**Arborist Report and Inventory-Addendum on Pages 18-19
March 19th, 2024**

3029 62nd Ave SE
Mercer Island, Wa

**Addendum to the original report
November 12th, 2024**

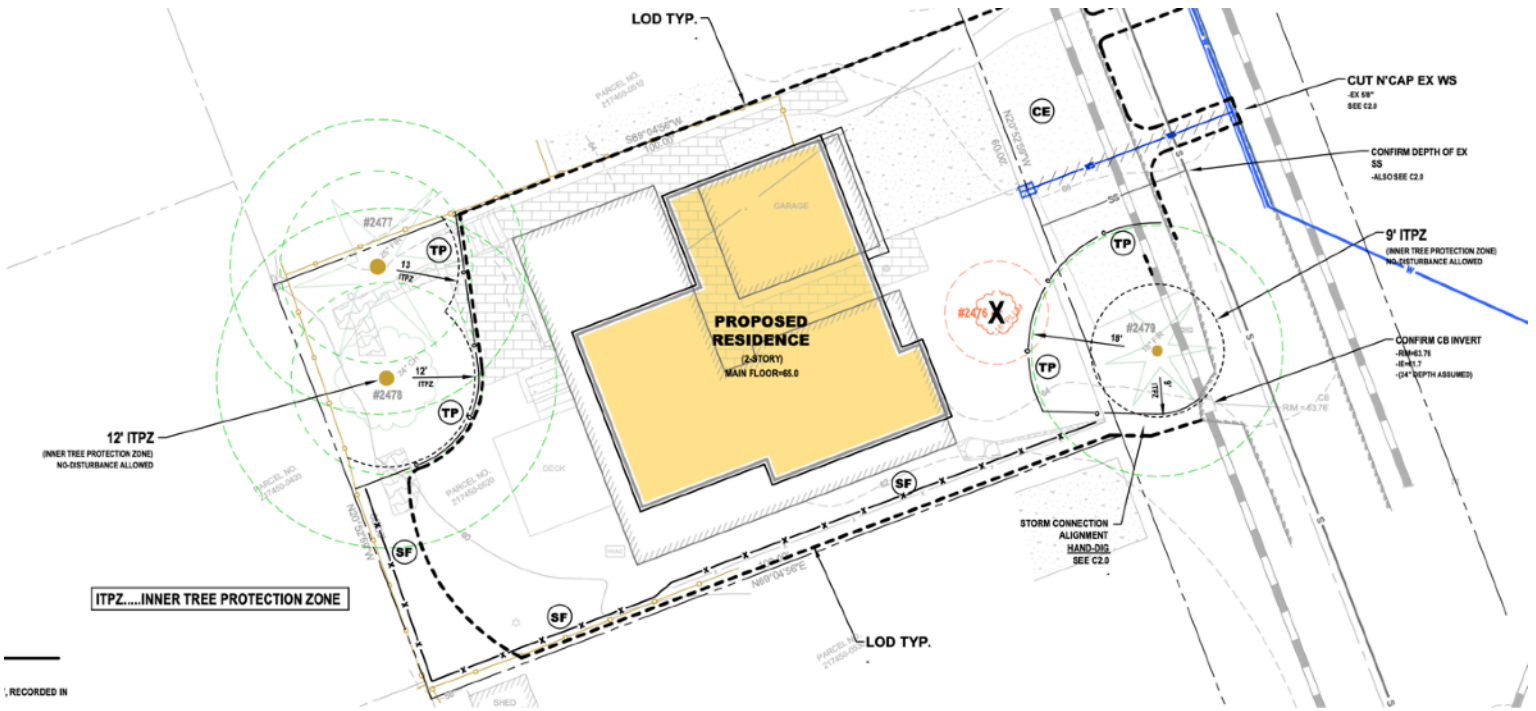
I have received some correspondence from the client about this site. There was an error on the site map in this arborist report and Tree 2479 was not labeled correctly. I have adjusted that page so that all of the trees are labeled correctly.

The client has made some modifications to the original approach in an effort to reduce TPZ disturbances to the trees that are being retained at the site. Only tree 2476 is scheduled to be removed. Here are some of the modifications that have been made since that previous submittal:

- Moved new water meter further north out of Tree 2479's dripline to have one less disturbance in dripline.
- added ITPZ radius to trees 2477, 2478, 2479
- added annotation about no disturbance within ITPZ
- adjust storm connection alignment in tree 2479 dripline to ensure no disturbance to ITPZ 9' radius
- fine tuned tree protection

I have looked at the new site plan that is available and the proposed disturbances are within the accepted tolerances and it is my professional opinion that the revised approach will not have an adverse effect on the health or the stability of the the trees that are being retained. A version of the updated Site Plan is included on the following page.

The tree protection fencing is scheduled to be installed at the limit of disturbance and outside of the inner tree protection zone of all of the trees that are being retained. The water line has been moved north so that it avoids the TPZ of Tree 2479 and the installation will not have an adverse effect on that tree. The fencing should be installed prior to the project commencing and needs to remain in place for the duration of the project.
